Access Compliance Report Public Rights-of-Way (Curb Ramps)

Main Street: SINGING_WOOD_DR Cross Street: FAIR_WEATHER_RD Location: E

ADA ID: RPRK211014130124 Ramp Type: Type 1 - Perpendicular Diagonal Initial Pass/Fail: Fail Overall Compliance: No Severity Score: 2

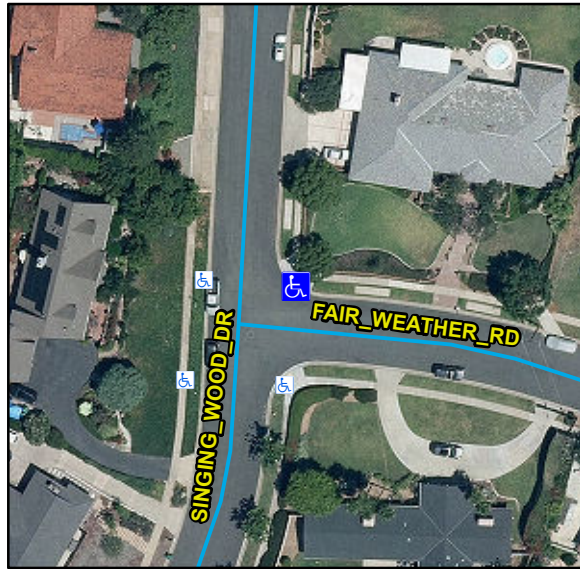
Compliance	Description	Data	Compliance	Description	Data
N/A	Ramp Length (in)	126	N/A	Flare Type LT	
Yes	Ramp Width (in)	48			N/A
Yes	Ramp Run Slope (%)	7.1	N/A	Flare Slope LT (%)	N/A
No	Ramp Cross Slope (%)	3.1	N/A	Flare Traversable LT	N/A
N/A	Landing Present	N/A	N/A	Flare Type RT	
N/A	Landing Length (in)	N/A			N/A
N/A	Landing Width (in)	N/A	N/A	Flare Slope RT (%)	N/A
N/A	Landing Run Slope (%)	N/A	N/A	Flare Traversable RT	N/A
N/A	Landing Cross Slope (%)	N/A	N/A	DWS Provided	N/A
N/A	Landing Movement Obstructed?	N/A	N/A	DWS Contrast	N/A
	Landing Movement Type	N/A	N/A	DWS Length (in)	N/A
N/A	Landing Shared	N/A	N/A	DWS Full Width	N/A
N/A	Clear Space	Yes	N/A	DWS Offset Left (in)	N/A
N/A	Clear Space To Crosswalk (in)	N/A	N/A	DWS Offset Right (in)	N/A
N/A	Marked Crosswalk 1	No	N/A	Marked Crosswalk 2	No
	Crossing 1 Direction	NW		Crossing 2 Direction	SW
	Marked Crosswalk 1 Width (in)	N/A		Marked Crosswalk 2 Width (in)	N/A

N/A	Ramp Inside Crosswalk 1	N/A	Yes	Ramp Inside Crosswalk 2	N/A
	Crossing 1 Slope (%)	8.1		Crossing 2 Slope (%)	6.1
	Crossing 1 Cross Slope (%)	2		Crossing 2 Cross Slope (%)	3.4
N/A	Gutter Ponding	N/A	No	Curb Slope	7.7
Yes	Gutter Lip Height (in)	0		Road Run Slope (%)	2.8
N/A	Gutter Run Slope (%)	N/A		Road Cross Slope (%)	8.5
N/A	Gutter Cross Slope (%)	N/A			
Yes	Overall Surface Condition: Acceptable		No	Perp Joint Present	No
	Cross Gutter Present?	No		Spandrel Present?	No
	Replace Cross Gutter?	N/A		Replace Spandrel?	N/A

Remove & Replace Curb Ramp With Two New Directional Ramps or Equivalent.
